Ref: 25-0325P/01

RE: Response to Information Request
New Beith Road, Silverbark Ridge (Part of Lot 911 on SP356636)
EDQ Reference: DEV-2026-FLA-4618

Response to Information Request

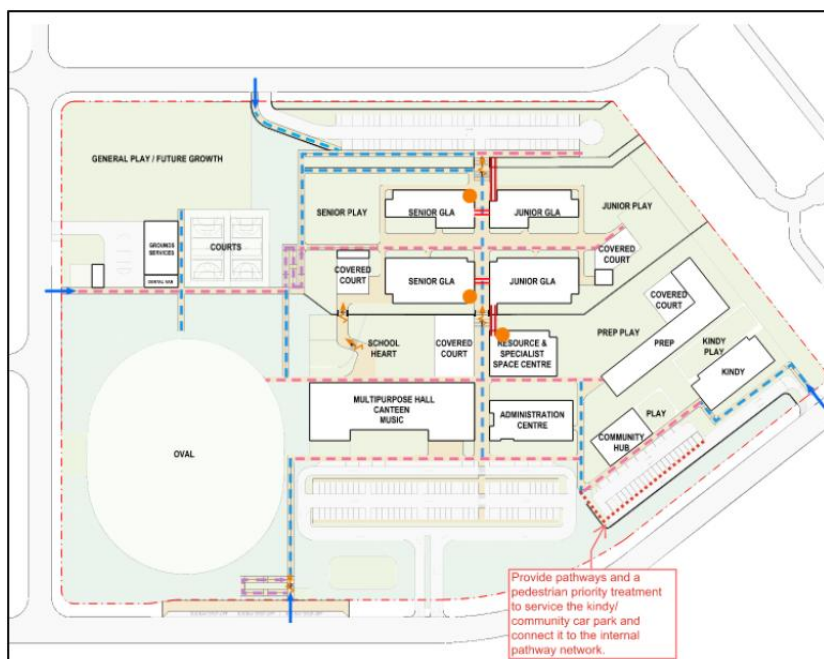
- Update the southeast access so that it is relocated further west, positioned entirely outside the functional area of the future signalised intersection, to demonstrate compliance with intersection design requirements and avoid operational conflicts.

- Relocate the bike store on the western pedestrian entrance closer to the centre of the school, as recommended in Section 3.4.2 of the Traffic Impact Assessment. this will improve accessibility and encourage higher active-transport uptake by placing the facility in a more convenient and visible location for students.

- Provide bicycle racks for visitor bicycle parking at the entrance of the Kindy/Community Hub.
- Provide a signage and line marking plan as required in Section 3.6 of the Traffic Impact Assessment. Alternatively, this can be conditioned as Compliance Assessment.

- Provide another pedestrian access point to the Trunk Collector (southern frontage) between the two vehicle crossovers.
- Provide pathways and a pedestrian priority treatment to service the kindy and community car park in the south-west corner of the site and connect it to the internal pathway network, as shown in the marked-up plan below.

Relocation of the southeastern crossover further west along the site frontage is not feasible due to the site's topography. The fall across the site has required the development to be benched into three distinct platforms. Vehicle access from the street level (RL 64.50) to the car park (RL 67.50) is provided via a ramp with a maximum gradient of 1:8.

Relocating the southeastern crossover further west would reduce the available ramp length required to achieve the necessary change in level, resulting in an unacceptable gradient and rendering the access arrangement unworkable.

To address operational conflicts, the southeastern crossover has instead been revised to operate as a left-in/left-out access. Further details are provided in Section 3.2.2 of the Traffic Impact Assessment.

The Concept Master Plan (CMP) has been amended to relocate bicycle storage to a location at the eastern side of the multi-purpose courts, in addition to the location north of the short-term carpark adjacent to the southern façade of the multi-purpose hall. Both locations are considered convenient to staff and students.

The Applicant accepts a condition of approval that requires provision of bicycle racks for visitor bicycle parking at the entrance of the Kindy/Community Hub.

The Applicant accepts a condition of approval that requires provision of signage and line marking as required in Section 3.6 of the Traffic Impact Assessment.

Provision of a third pedestrian access point at the site's southern frontage is not feasible due to the site's topography and level constraints. The steeply sloping nature of the site has required the development to be benched into three distinct platforms.

To achieve compliant pedestrian access between the street level (RL 64.50) and the car park level (RL 67.50), a ramp with a maximum gradient of 1:14 would be required. Accommodating such a ramp within the available area would necessitate a substantial ramp configuration, which cannot be achieved due to the site's limited dimensions and spatial constraints. Accordingly, the provision of a third pedestrian access point from the southern frontage is not practicable.

The CMP has been amended to include provision of a pedestrian path at the front of the carparks located within the kindy and community parking area; and provision of a pedestrian crossing connecting to the wider internal pedestrian network.
